Design Review Board Recommendations ..... 6-18

GREEN LAKE MIXED-USE

A PERSPECTIVE VIEW - NORTH ELEVATION MASSING

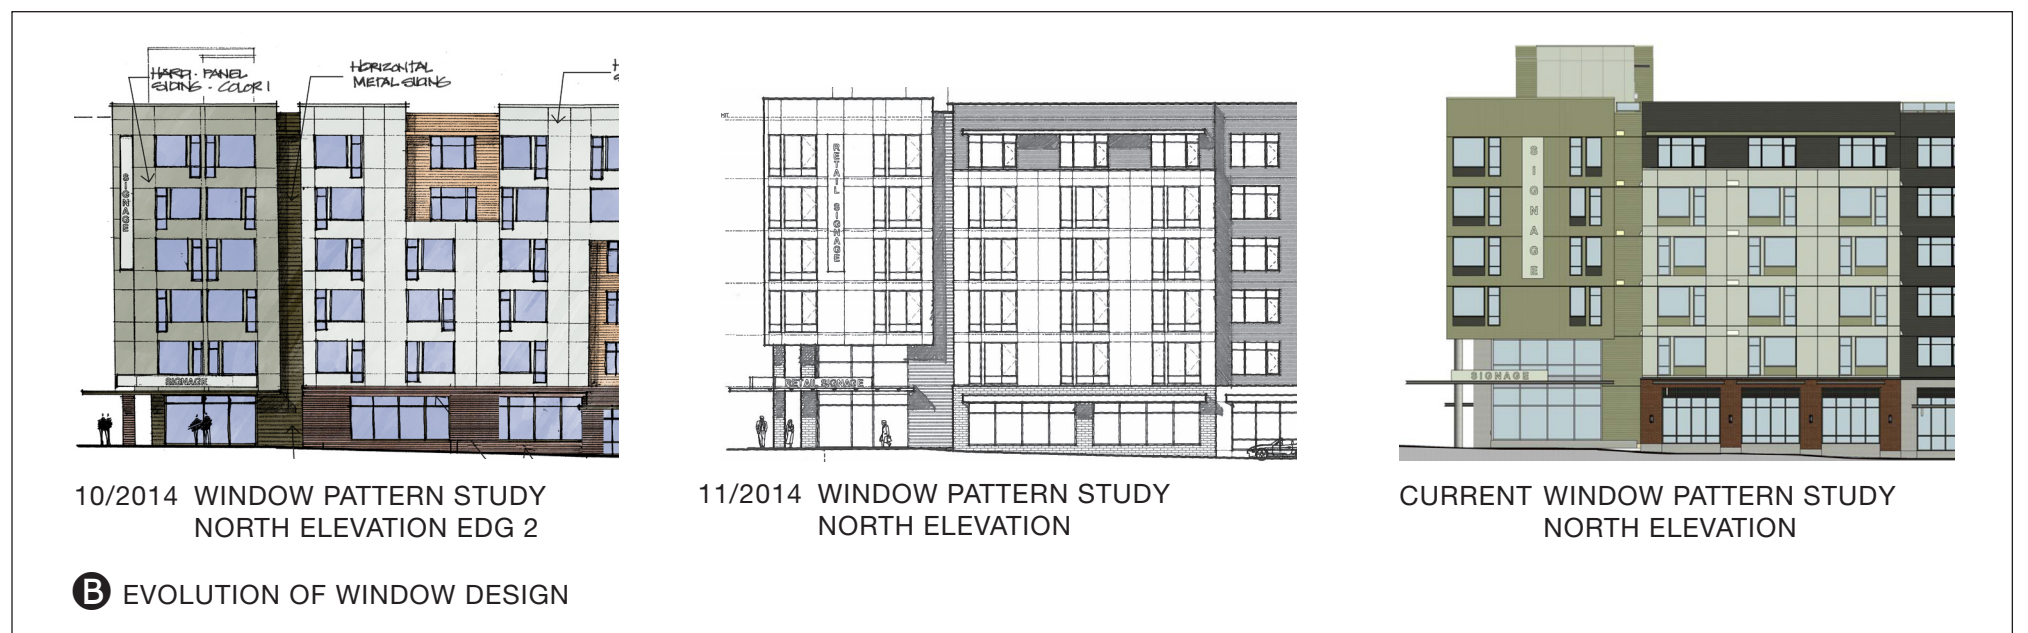
*The Board felt the design concept should be simplified. At the Recommendation Meeting, the Board would like to see a much stronger composition where the texture and material changes are justified by the massing or architectural concept (DC2-A, DC2-B, DC4-A).*

*The Board suggested that the design concept may evolve to define the top two stories separately and/or that the upper level massing could better define the commercial entry or through block connection (DC2-A, DC2-B, DC4-A).*

The upper level massing has been redesigned for a simpler, stronger composition. The underlying driving idea is to step the massing down as it moves from the prominent intersection on 5th Ave NE towards the lake. This idea is represented in both plans and elevations.

A strong residential entry massing above a two-story recessed base is the symbolic response to the gateway northeast corner at the site. Moving along the frontage of NE 71st Street, the massing of the building at residential levels steps back and changes material to reveal a primary form, clad in metal siding. This primary form is fully exposed at the building's center, responding to and aligning with, the through-block connection of the Green Lake Village project to the north.

From this primary metal finished massing, modulation is introduced by protruding three cementitious panel forms. Toward the west of the building, these cementitious forms step down another floor. This step exposes two top levels of recessed metal siding, forms the relationship of our most western mass with the two-story separation of the upper levels of our neighbors' in the adjacent building. Additionally, this two story step recognizes the neighborhood grading sloping to the lake.

At the through-block connection, the massing is broken at both the north and south ends, highlighted by changes of material, profile and color, and allows more natural light in the connection space. See Graphic A.

The windows are designed to portray a single "punch" by including the accent color panel under the larger picture window, creating a single rectangular composition. Then, to soften the elevation forms, we are painting these panels to match the color of the metal panels used elsewhere. Overall, this is now a much simpler composition. (DC2-A, DC2-B, DC4-A) See Graphic B.

Consistent with the overall composition noted above, we evolved the concept to strengthen the top by recessing the upper one and two stories and by changing massing materials. The top mass of the protruding bays cascades at the through-block connection. Simultaneously, the gasket that isolates the west wing of the composition, plunges from the top of the building to the connection passage. The intentional massing play at the through-block connection forms the architecture and announces the connector's location. See Graphic C.

NORTHEAST RESIDENTIAL ENTRY VIEW

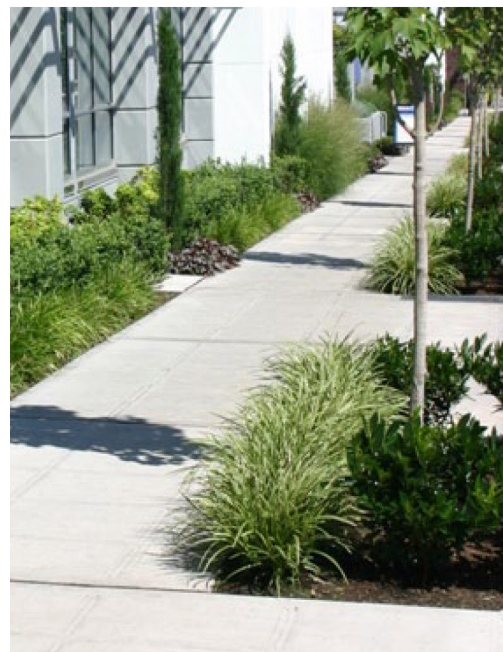
*The primary corner entry should be designed with a better vertical proportion. The Board agreed the entry should be a two story entry or designed to appear as a two story entry (CS2-C, DC2-B).*

*Provide a strengthened expression of the flat iron architectural concept at the corner (DC2-A and B).*

*The first floor setback at the corner and along the NE 71st Street façade creates an enhanced pedestrian experience and a 9-foot sidewalk. The ground level setback should be maintained as the project develops (PL1-B).*

The primary corner has been redesigned to appear as a two story entry. The second floor space was “pulled-in” to match the street level entry wall and the storefront was extended up for a consistent two story look enhancing the “entry porch” element, as previously shown and supported by the Board at the EDG meetings. The space at the second level is anticipated to be the leasing office, which is compatible with the design expression. The overhead canopy has been raised as well, so that its functionality as overhead weather protection can be maintained while also completing the entry composition. See Graphic A.

By changing window location, pattern and exterior material at this corner, we have modified the design to express a stronger two story street level appearance, with a strong, crisp outside corner. The combined effect strengthens the expression as well as provides a better window layout for the interior. See Graphic A.

The setback at the first floor corner and along NE 71st Street has been maintained. See Graphic B.

THROUGH BLOCK ENTRY VIEW

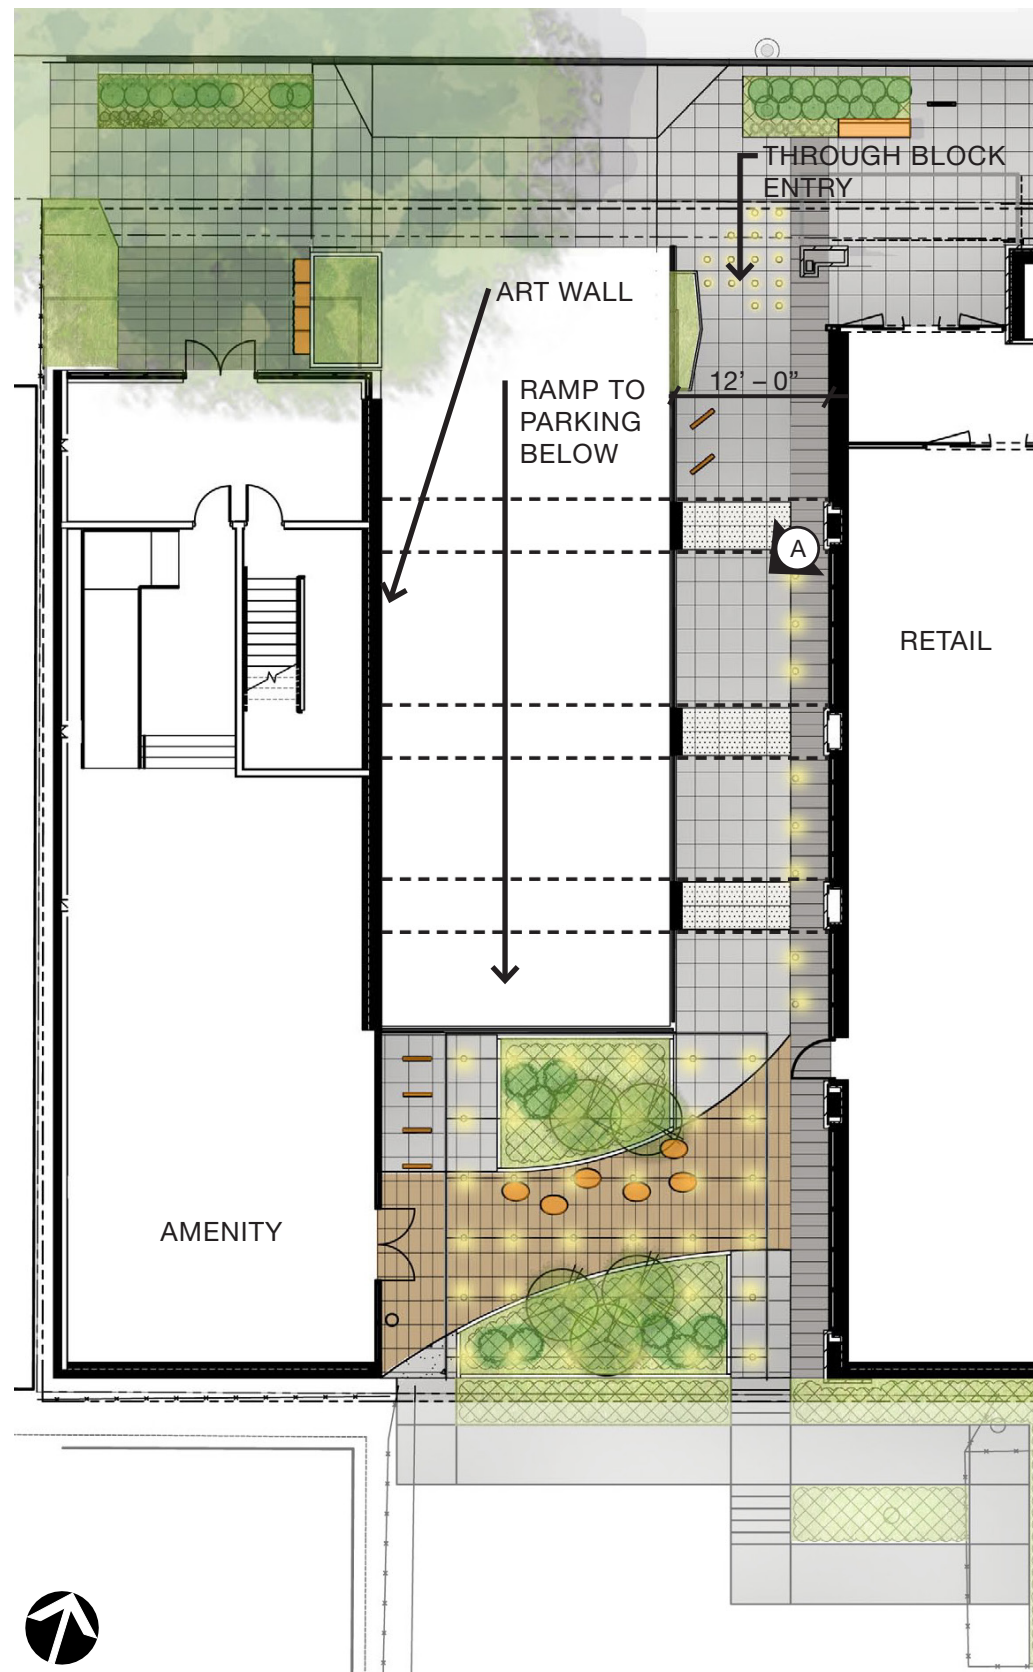
*The Board agreed the north entrance of the through block should be developed in conjunction with the vehicular ramp to make the through-block feel more open. The Board noted that the wall separating the through-block and the ramp should be designed as an integral artist element to the through block space (CS2-B, PL1-B, DC1-B, DC2-D).*

The design has been carefully studied to maximize the pedestrian space at the north entry of the through-block connection.

The safety wall between the driveway and the walk consists of a short concrete stem curb, atop which is placed an open and artful metal guard-rail. Use of a metal railing, rather than a solid wall, is intended to provide transparency; we propose extending the guardrail to the north edge of the ramp for better pedestrian safety. The railing will include recurring art elements symbolizing the variety of activities in Green Lake neighborhood, such as biking, kayaking, running/walking, etc. These elements would be integral to the through-block space, serving as a connection between the project, its surroundings and residents (PL1-A & B). See Graphic A.

A SOLID PANEL DOORS AT LOADING / SOLID WASTE / RECYCLING

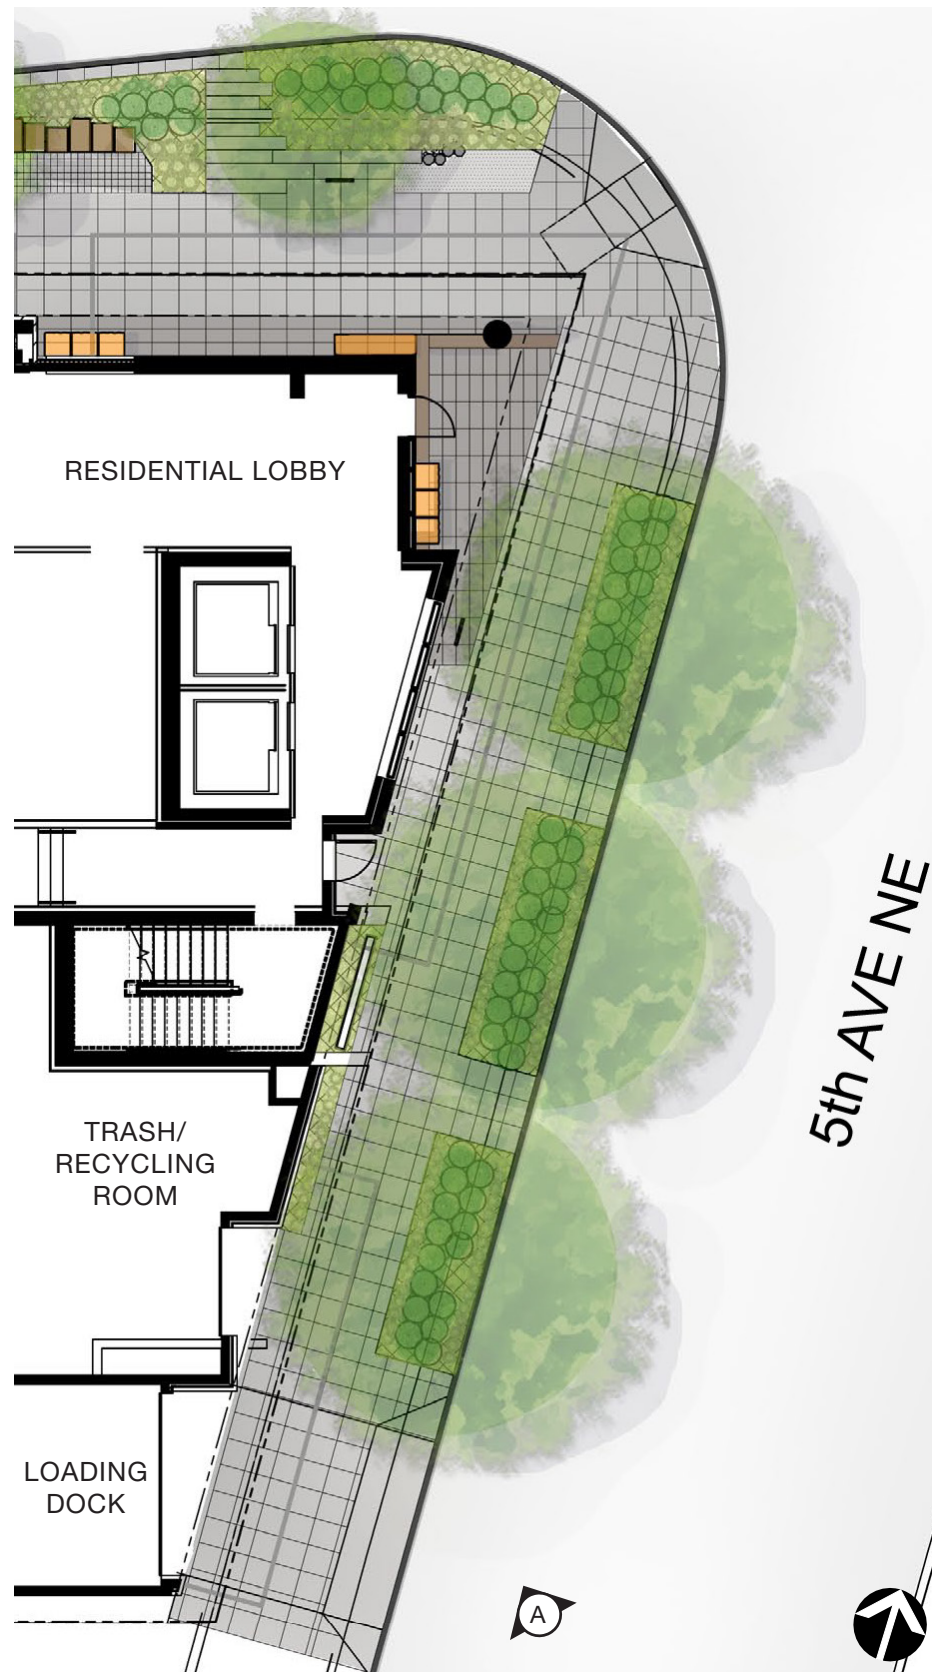
*At the Recommendation Meeting, the Board requested more detail for the screening for the solid waste and recycling storage space on the 5th Avenue NE street façade. Screening should minimize visual impacts and odor impacts to the sidewalk (DC1-C).*

The solid waste and recycling areas are located in the SE corner of the site, away from the pedestrian activity on NE 71st Street. The east elevation is also subject to the street level transparency requirement.

A code compliant solution still leaves the question of visual impacts of the Trash/Recycling room from the right-of-way. Odor and view impact will be addressed by using the solid roll-up doors, which we believe are better resolution. This will require a design departure from the transparency requirement.

We request this departure from the board to mitigate this concern of the Board, the Owner, as well as the whole neighborhood. See Graphic A, as well as Page 21 for more details on design departure.

C NORTH ELEVATION STREETSCAPE

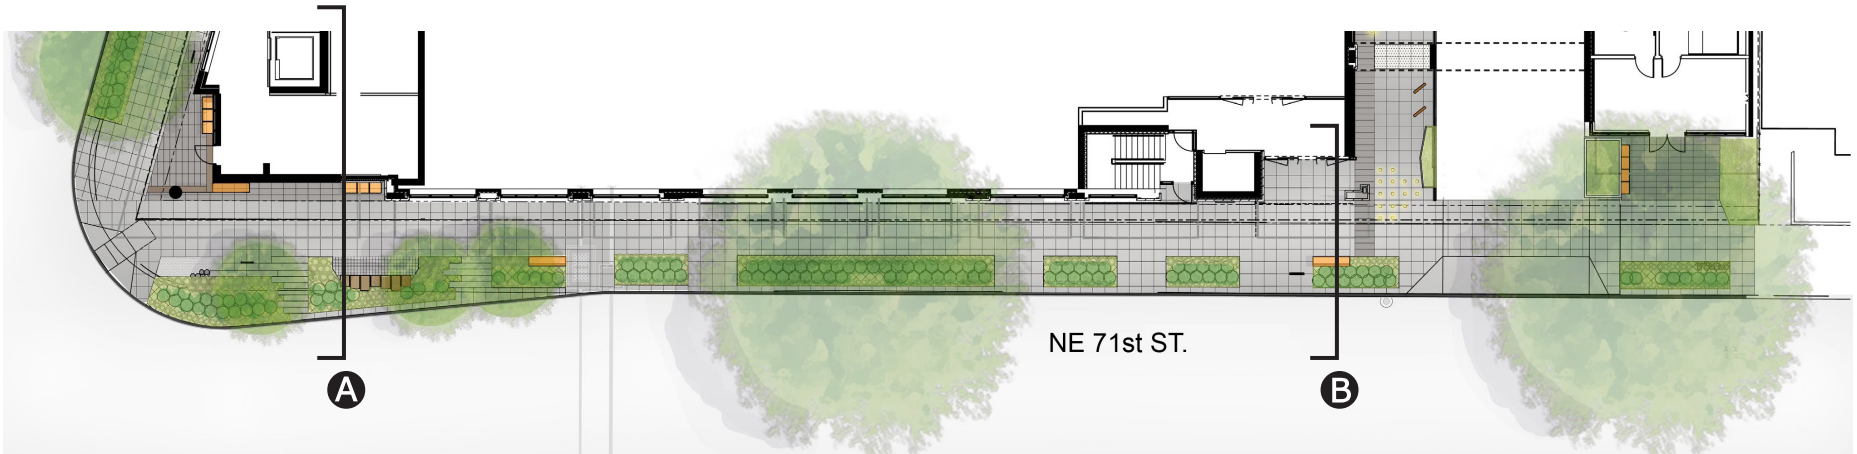
The planner expressed a concern about the street-level transparency along the street façade because of the mechanical louvers and height of the awnings. Furthermore, it was noted that the awning height should be 10' minimum above sidewalk.

This concern remained even after we located most of the overhead weather protection at the height desired by planner, with exception of two locations. See Graphic C.

Note that both SMC 23.53.035.B.4 and SDOT Municipal Code Section 15.10.020 call out the lowest point of the overhead protection to be minimum of 8'-0" above the sidewalk elevations. We feel that lower weather protection better serves pedestrians, and that the revised awning heights are not excessively low.

An additional constraint is that the mechanical systems for retail T.I. will be done separately from the shell and core permit, and only schematic T.I. mechanical drawings are currently available. For this reason, we show the top section of the storefront windows reserved for louvers. At the tightest point at the easternmost retail storefront window, the bottom of the louvers is approximately 9'-6" A.F.F. which will not affect the street-level transparency requirement. See Graphics A, B and C.

We would appreciate Board's guidance on this issue, for we think that the proposed weather protection height, and potential mechanical louvers locations will not create transparency issues along the street façade.
